## Revised preliminary development plan for 44<sup>th</sup> St./8<sup>th</sup> Ave. PUD

(PUD0603C) Great Lakes Convenience, Inc., 6785 Whitneyville Rd. SE, Alto, is requesting revised preliminary plan approval for a PUD (not the PUD rezoning because it is already in place) (the application for the second final development plan to be subsequently submitted) for a gas station/convenience store, retail/bank building, drive-through restaurant and three apartment buildings on a parcel of land described as P.P. # 70-14-26-200-077, located at 850 44<sup>th</sup> St., in a (PUD) Planned Unit Development district, Georgetown Township, Ottawa County, Michigan.

**RISH DESIGN & BUILD INCORPORATED**  
 enterprise gas & retail  
 gas station  
 pumps/ canopy

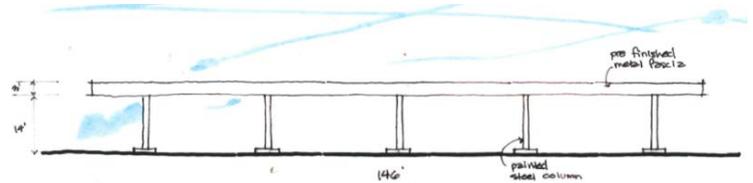
**Proposed elevation of the gas pumps (in the minutes the Planning Commission stated that the flat canopy would be acceptable if located in the interior and if the building coordinated with the dental office building):**

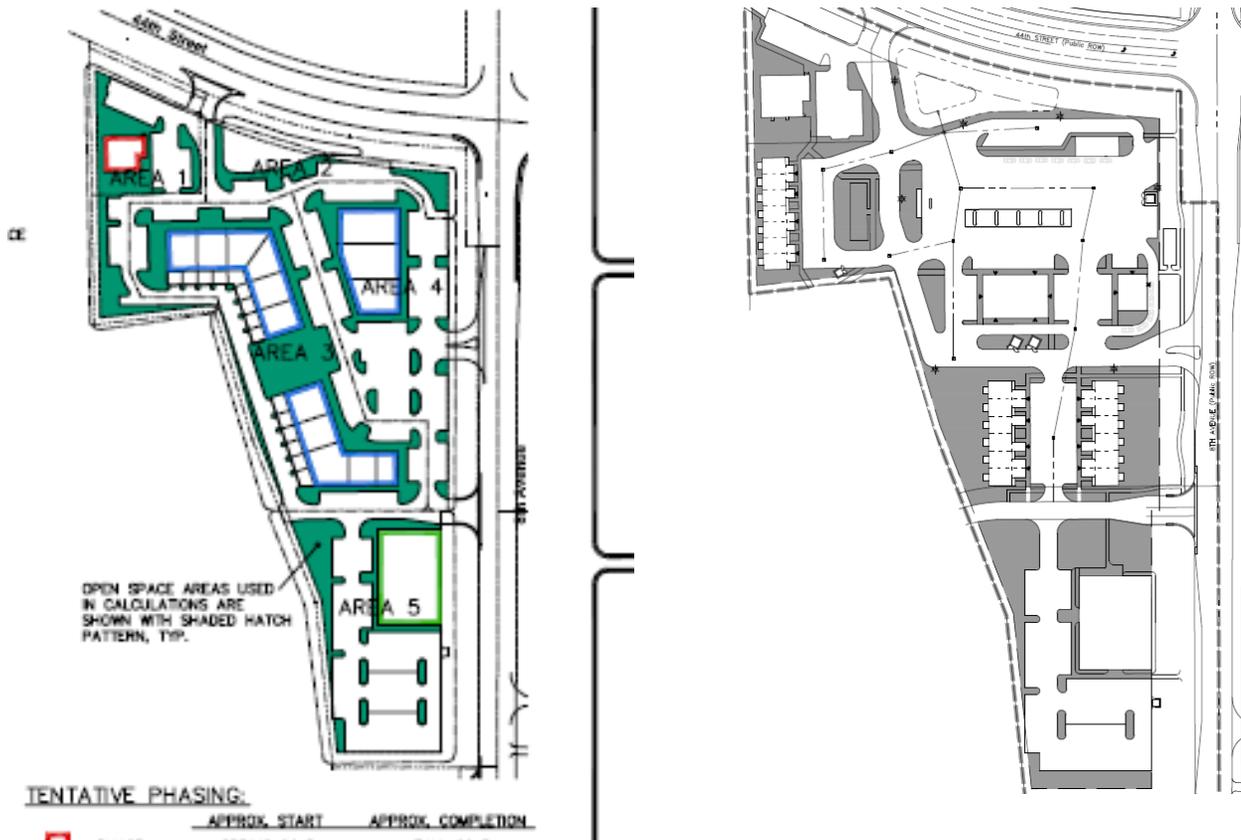
**The previously approved preliminary plan indicated that there is 20% of open space as defined in the ordinance, which included a pedestrian plaza with water feature, along with greenspace and landscaping. This feature has been eliminated and landscaped berms and pedestrian plaza with benches has been added.**

Below is the open space pedestrian plaza with water feature that was approved with the revised preliminary plan. This has been eliminated in the new plan.
